Security and CPTED Report

Project Address: 216-238 Keira St, 221-291 Crown Street and
86-90 Burelli Street, Wollongong, NSW
2500

Report Ref: 390844-Wollongong Developments No.8-
CPTED-Report-RevH

10.0 Annex A – CPTED Mark-up of Architectural Plans

Figure 8-2 - DtS Re-entry from Fire Isolated Exits as per D3D27(2)(a).

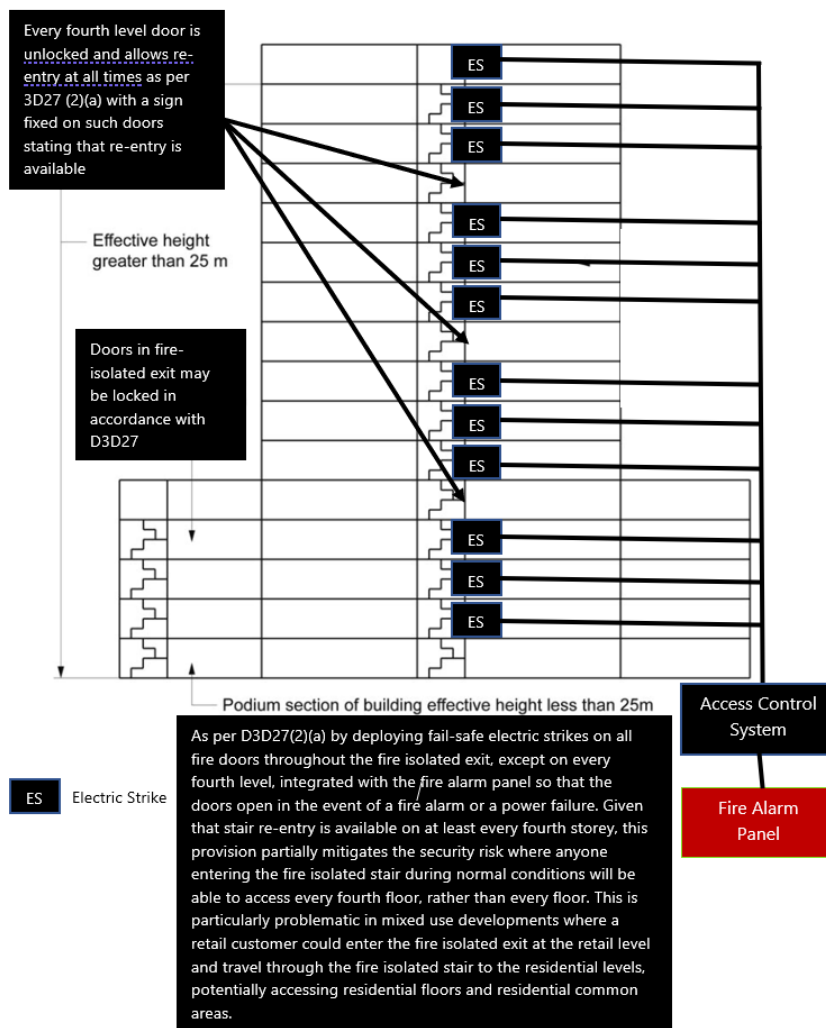
- A fail-safe electronic door release system linked to the fire alarm, ensuring automatic unlocking during emergencies.
- Under D3D27(2)(a), by deploying fail-safe electric strikes on all fire doors throughout the fire isolated exits, except on every **fourth** floor ensures that the fail-safe devices fitted to the fire exit doors automatically unlock the door upon activation of a fire alarm. See Figure 8
- Additionally, D3D27(2)(b) emphasises a more risk-mitigated approach by implementing fail-safe electric strikes on doors at **all** levels within the fire-isolated stairs, as well as installing intercoms and appropriate signage inside the fire stairwell. See Figure 8.

Figure 8-3 - Dts Re-entry from Fire Isolated Exits D3D27(2)(b)

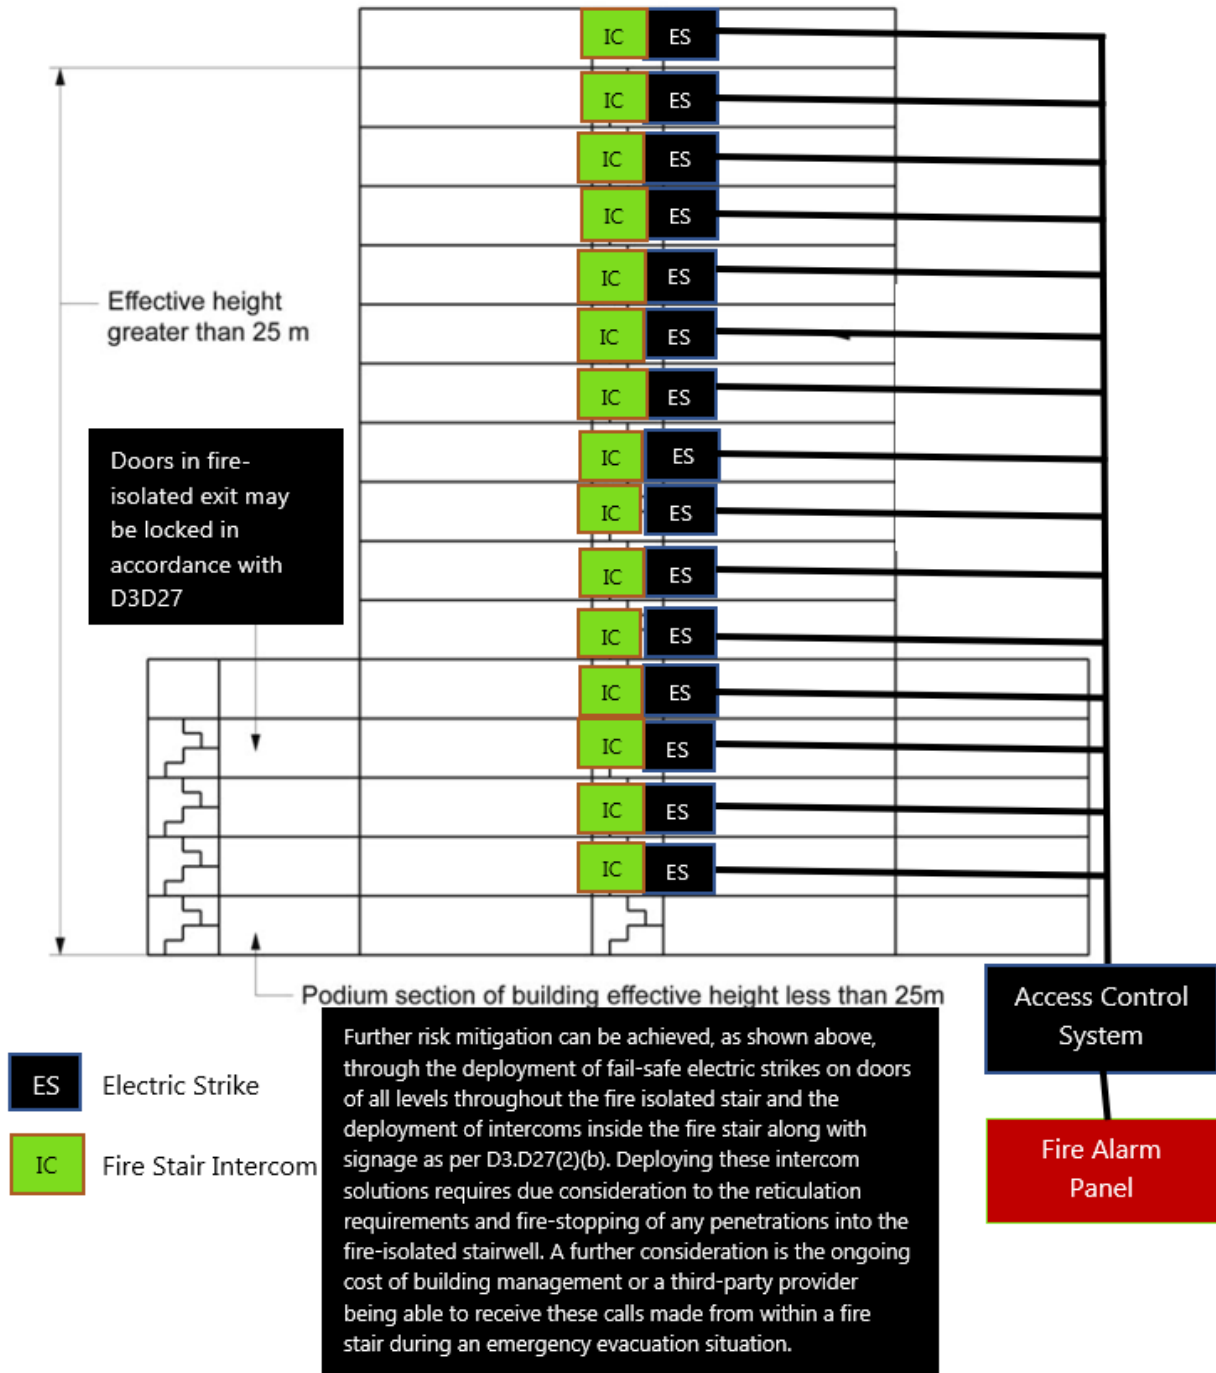
- Applies to buildings over 25m in height
- Relevant to fire-isolated stairwells servicing these heights
- Install a fail-safe electronic door release system linked to the fire alarm for automatic unlocking.
- Designer can implement either design for implementing fail-safe electric strikes throughout stairwells as Figure 8-2 and Figure 8-3 highlight.

Drawing Name: Basement 01

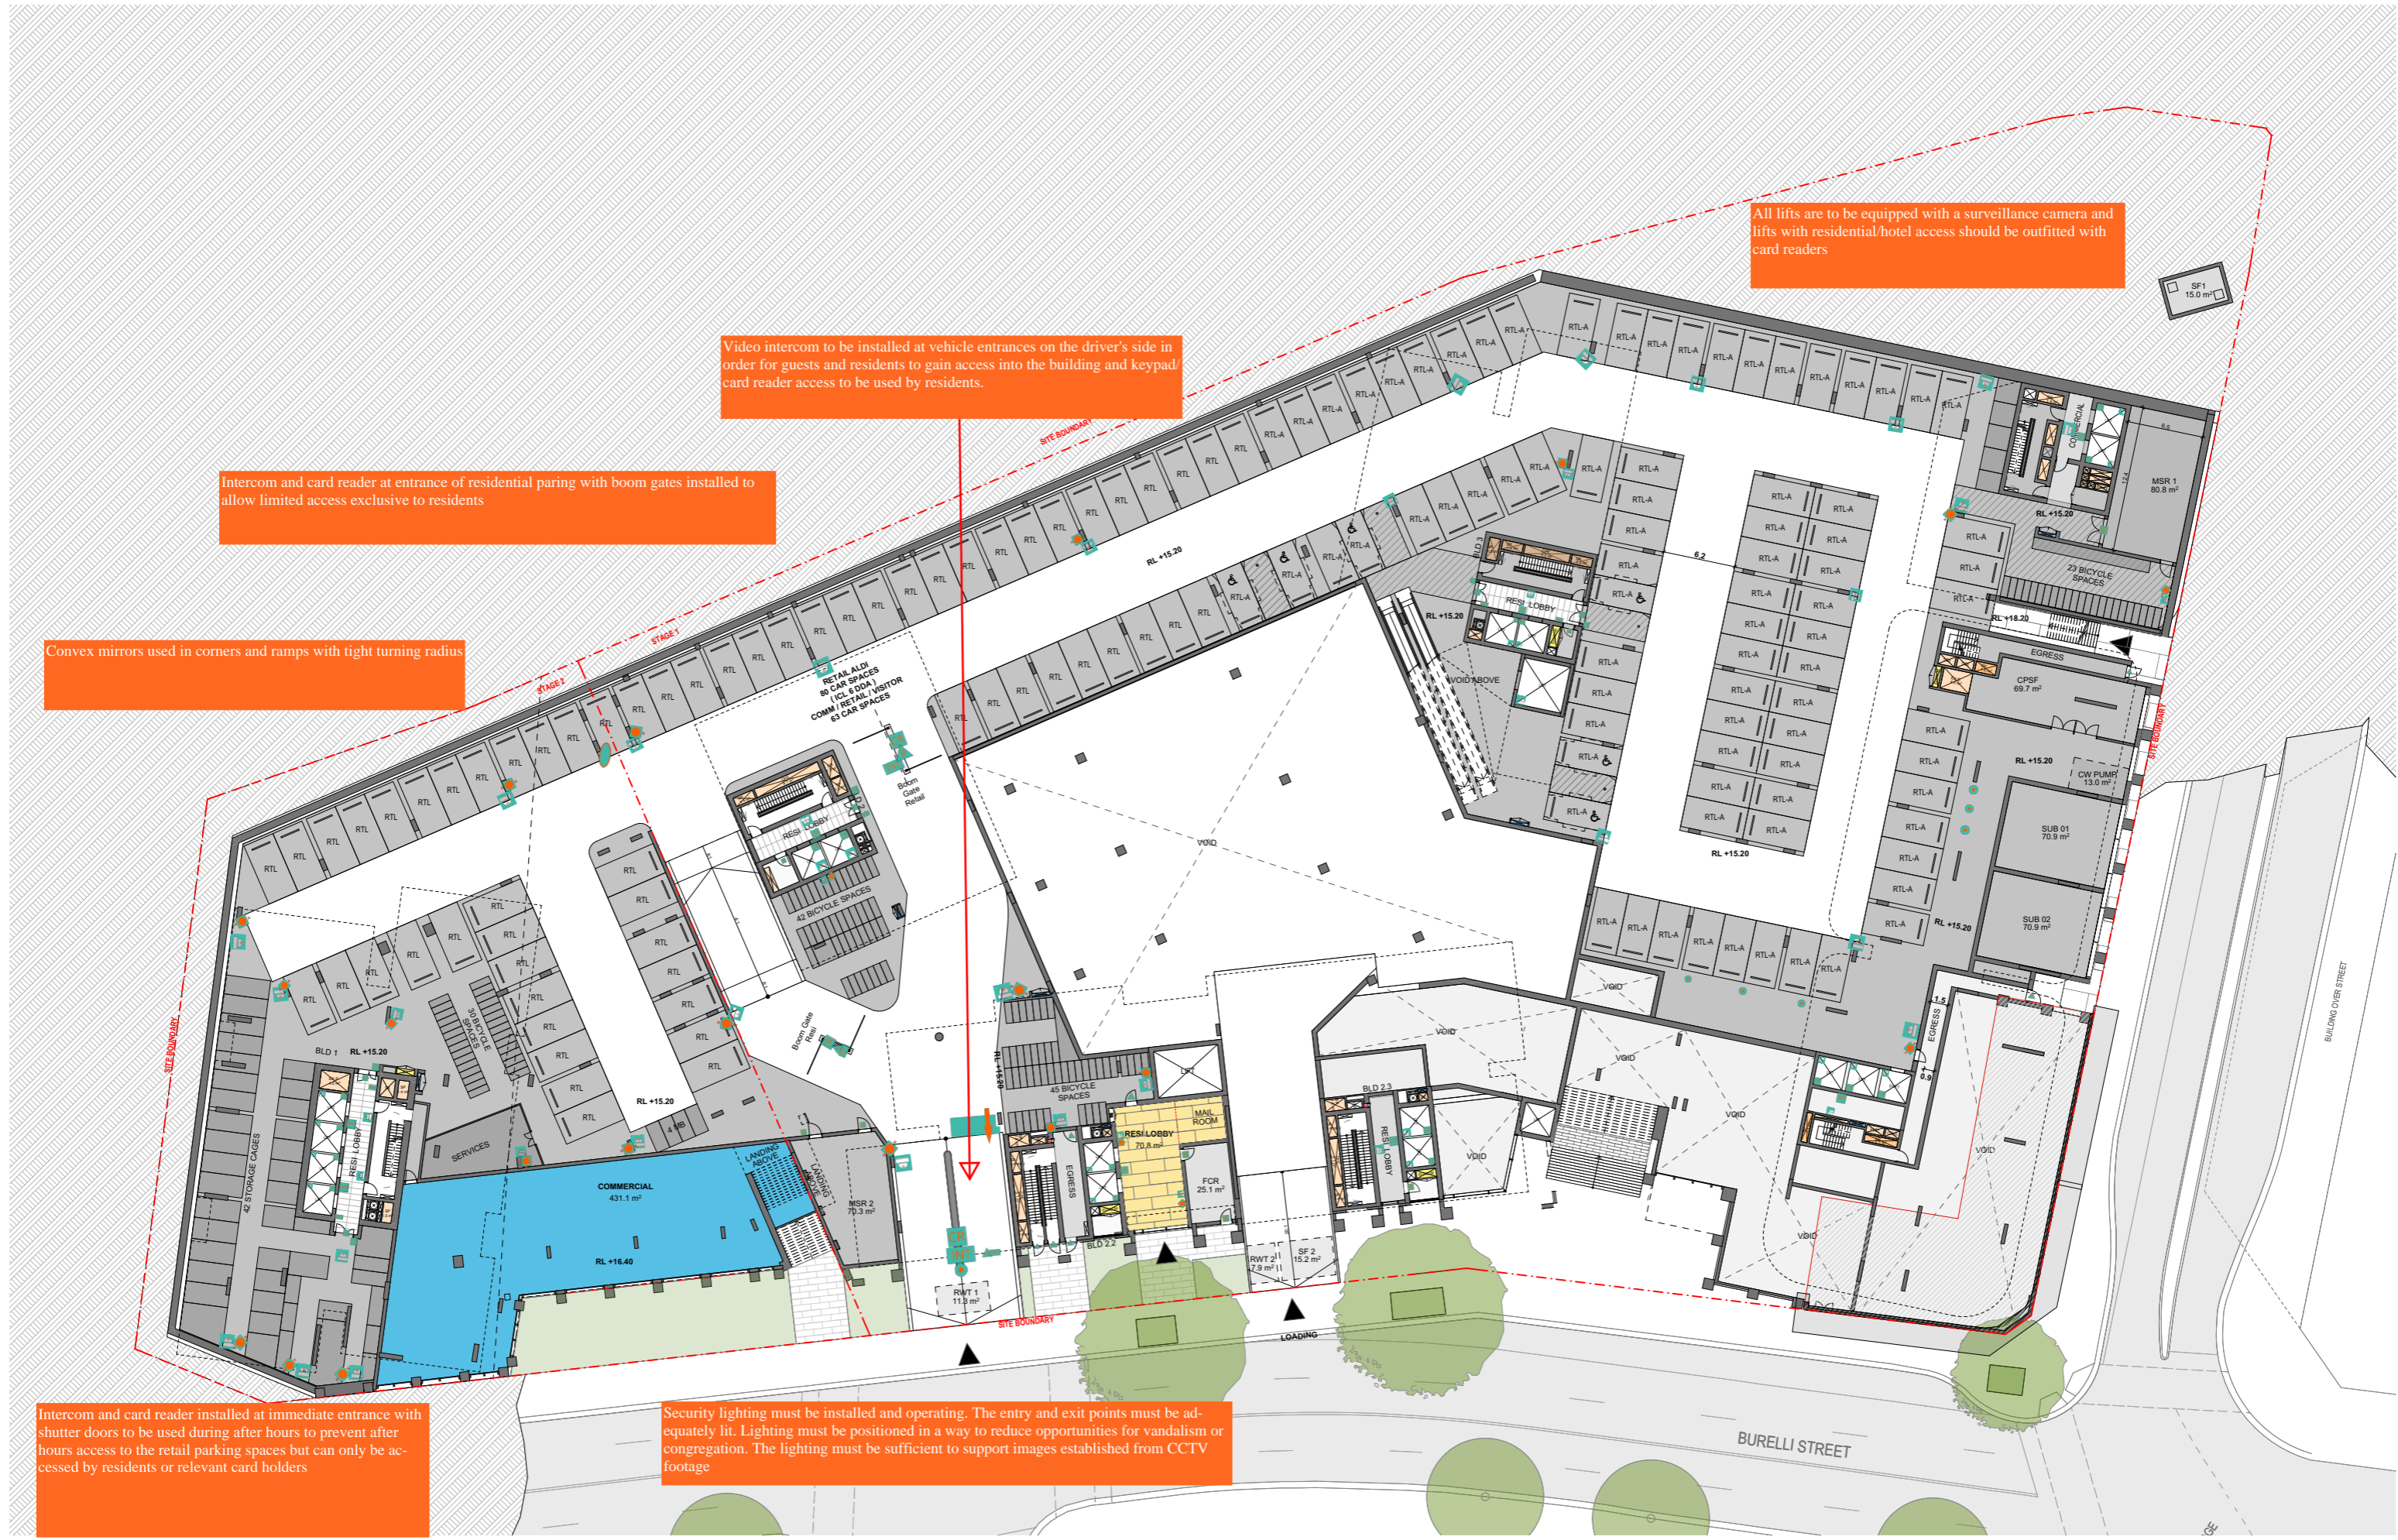
All lifts are to be equipped with a surveillance camera and lifts with residential/hotel access should be outfitted with card readers

Video intercom to be installed at vehicle entrances on the driver's side in order for guests and residents to gain access into the building and keypad/card reader access to be used by residents.

Intercom and card reader at entrance of residential parking with boom gates installed to allow limited access exclusive to residents

Drawing Name
Mezzanine level

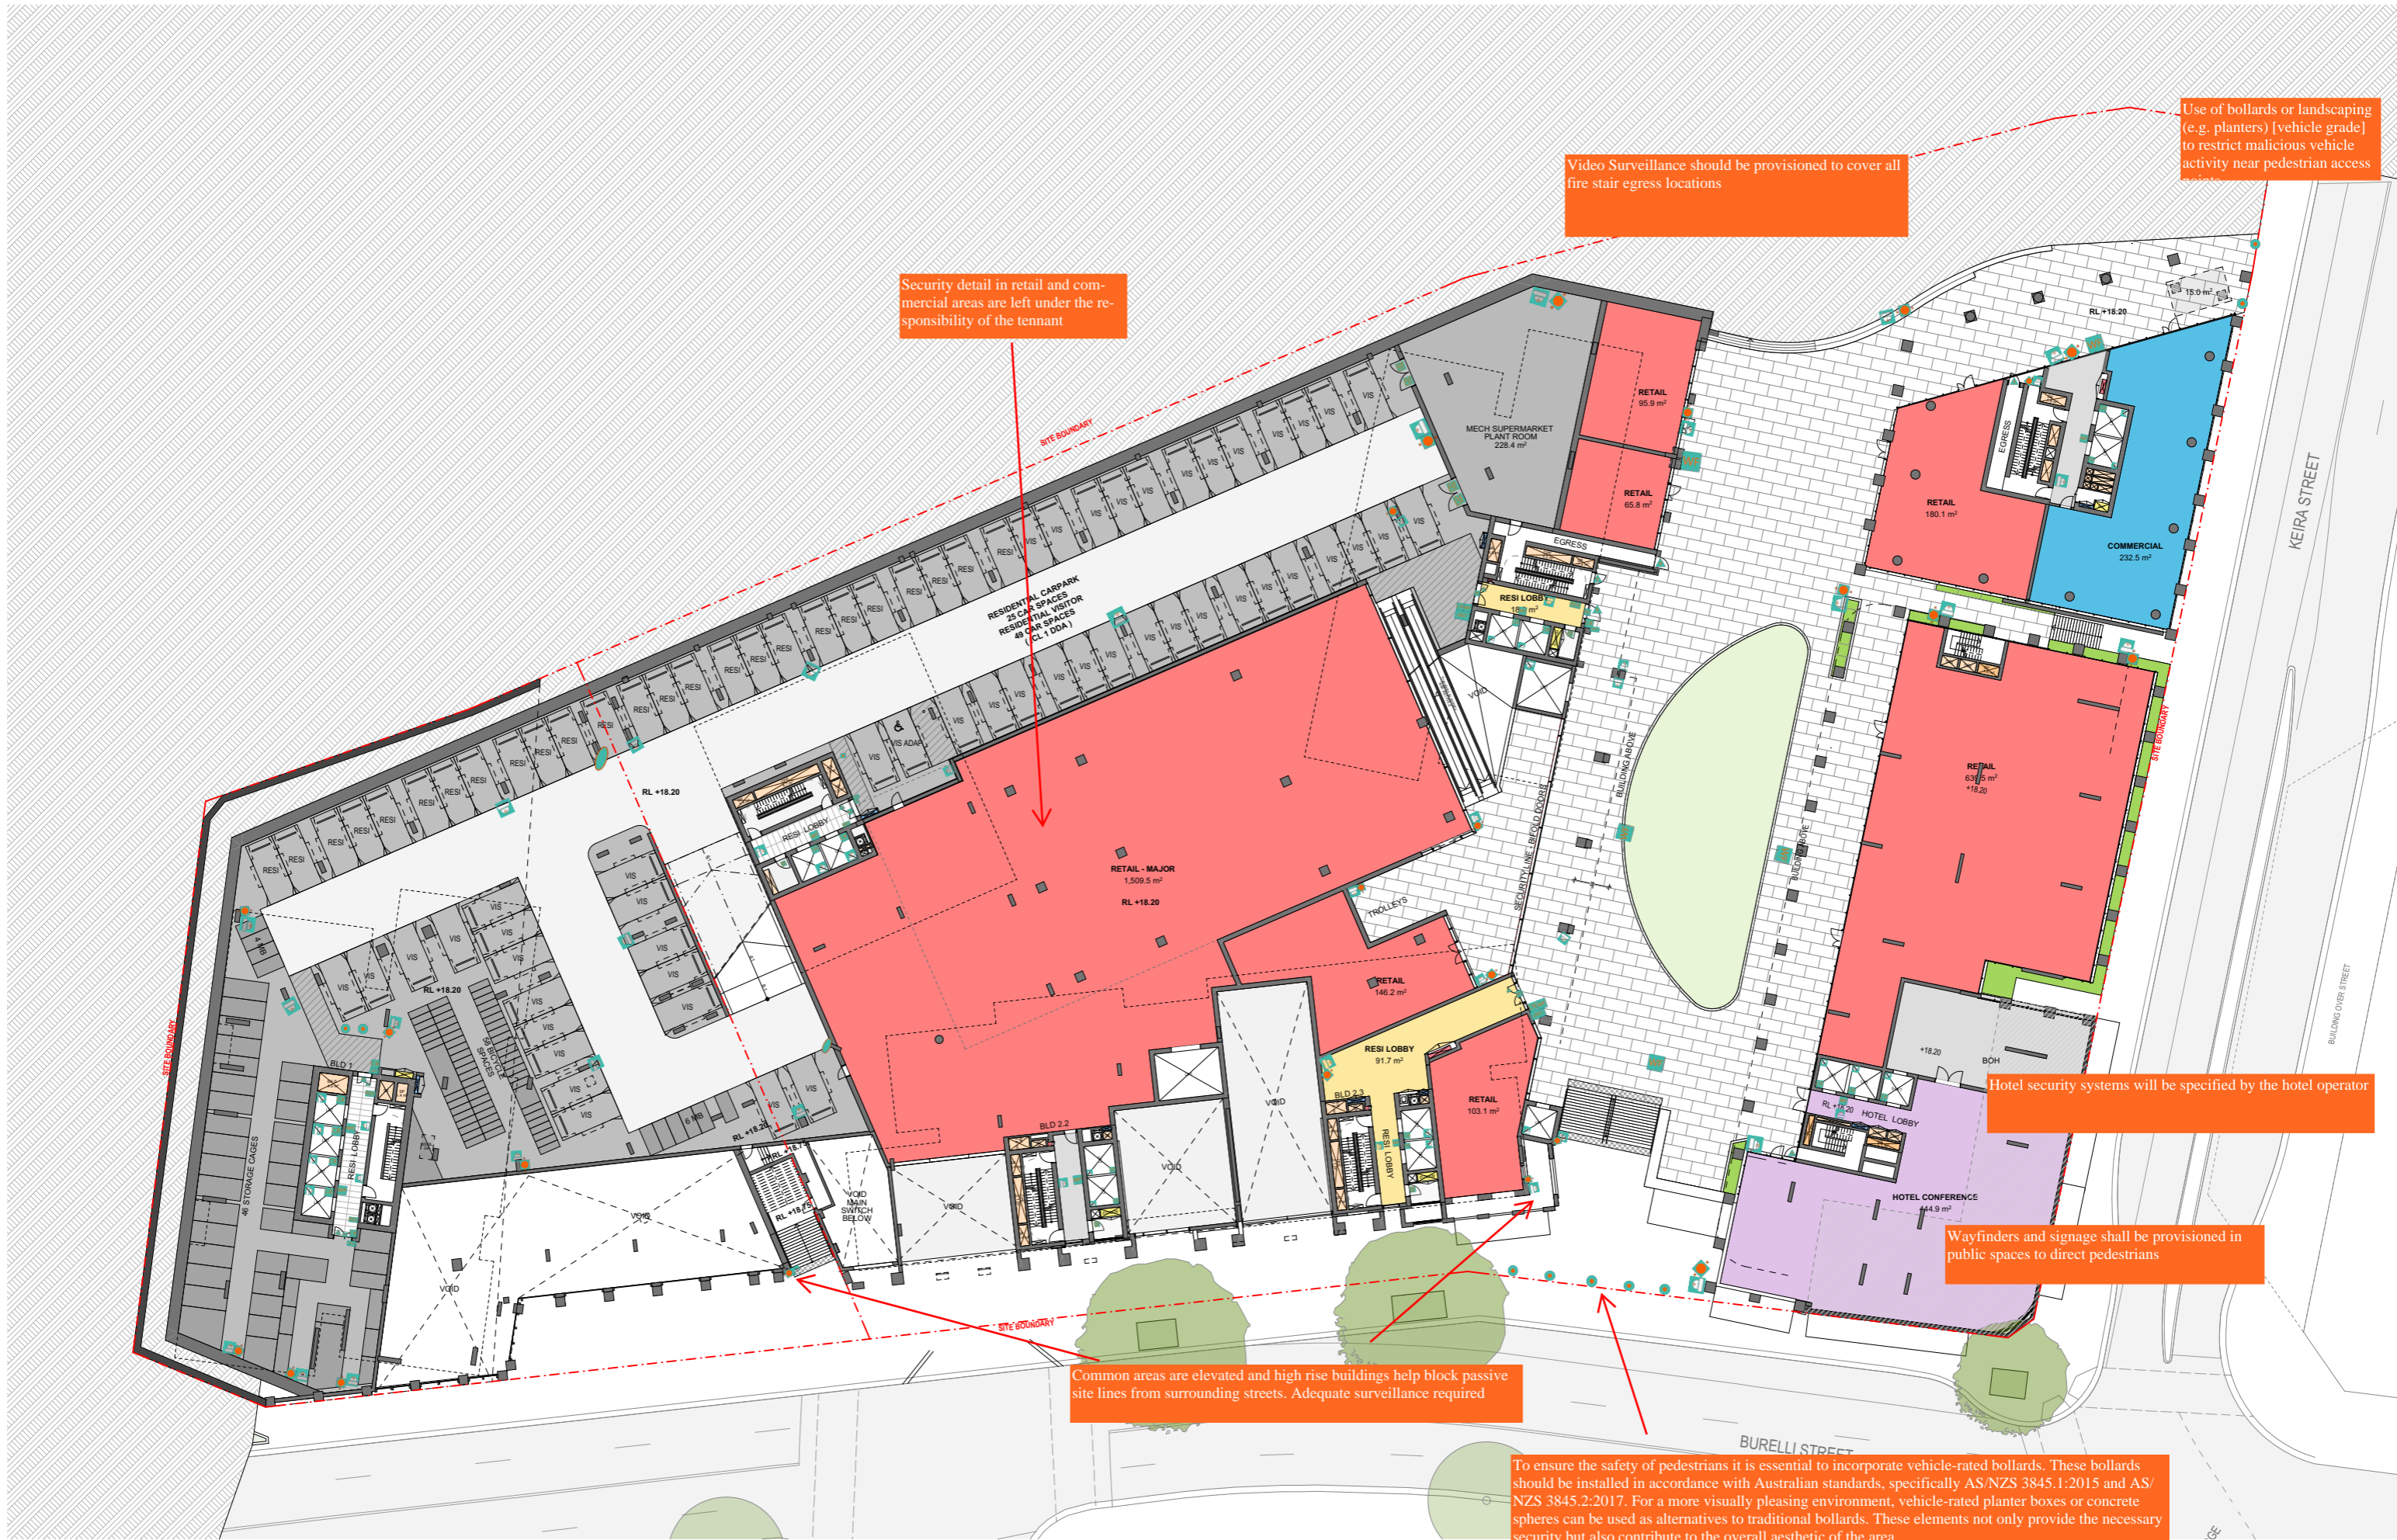
Use of bollards or landscaping (e.g. planters) [vehicle grade] to restrict malicious vehicle activity near pedestrian access points

Security detail in retail and commercial areas are left under the responsibility of the tenant
